K270/K370 Front Axle Sway Bar Links

Title	17KWE: K270/K370 Front Axle Sway Bar Links
Search Words	
Bulletin No.	17KWE
What's New Abstract	Safety Recall – The front axle sway bar links may be assembled incorrectly. Inspect for missing or incorrectly installed washers and install them correctly as needed.
Supplier	Kenworth
Description	The front axle sway bar links may be assembled incorrectly on certain vehicles.
Release Date	
Introduction	<p>Customer letters will be sent stating that parts will be available November 13.</p> <p>Kenworth Truck Company has decided that a defect, which relates to motor vehicle safety, exists in certain model year 2009-2018 K270 and K370 vehicles manufactured from January 14, 2009 through August 21, 2017. These vehicles may have a front axle sway bar link assembled incorrectly. A missing or incorrectly assembled hardened washer used to attach the front axle sway bar link to the frame rail can result in the sway bar link becoming detached from the frame rail.</p>

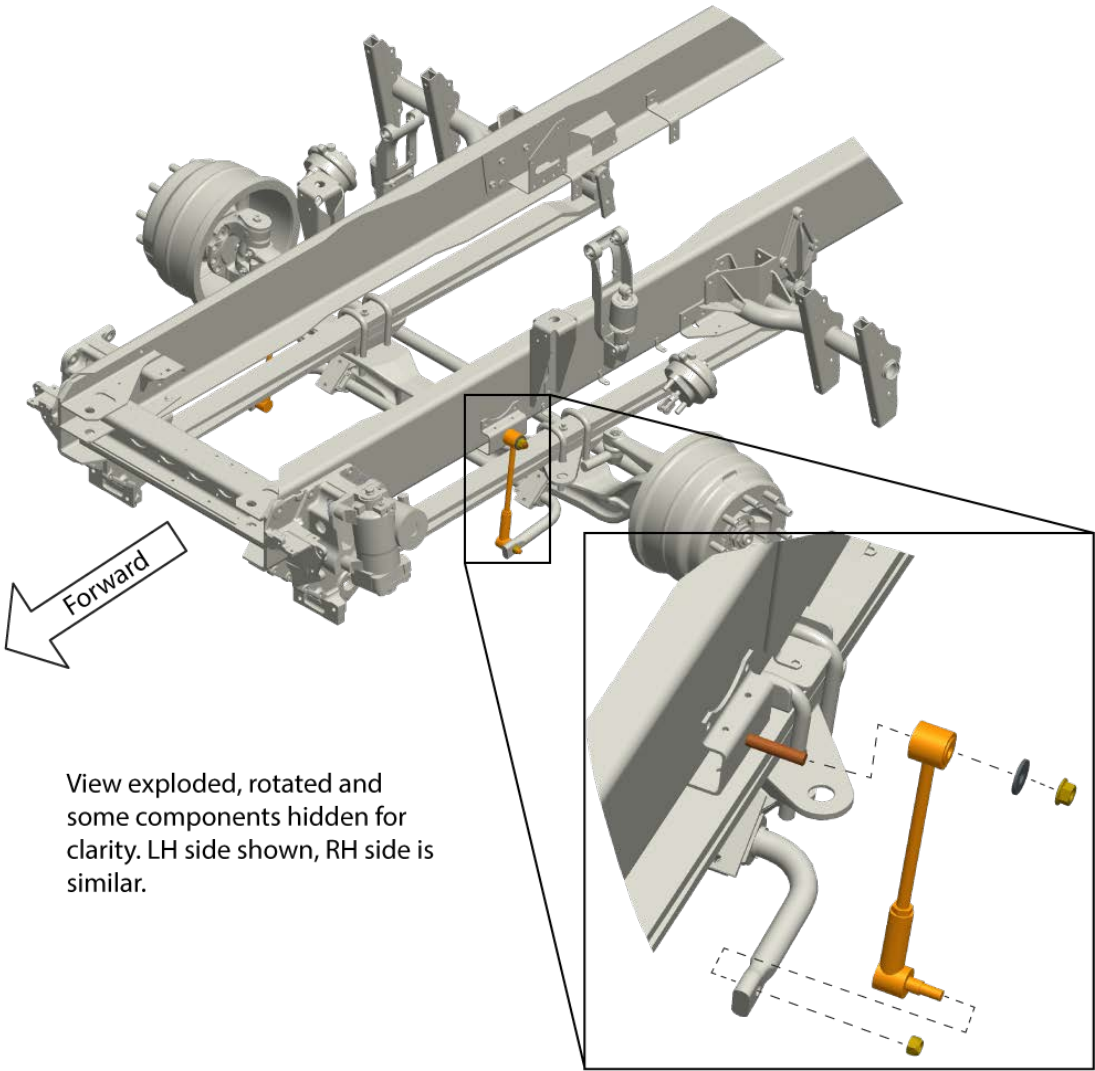
1. Inspect the upper sway bar link attachment on each side of the vehicle and confirm that the hardened flat washers are installed as shown in the images below.
2. Move the flat washer to the correct location, if needed.
3. If the hardened flat washer is missing, install the hardened flat washer in the correct location.

<p>View exploded, rotated and some components hidden for clarity. LH side shown, RH side is similar.</p>
<p>Shipping</p>	
<p>Freight</p>	
<p>Contact</p>	
<p>Attachments</p>	<p>Dealer\Chassis List Customer Letter</p>
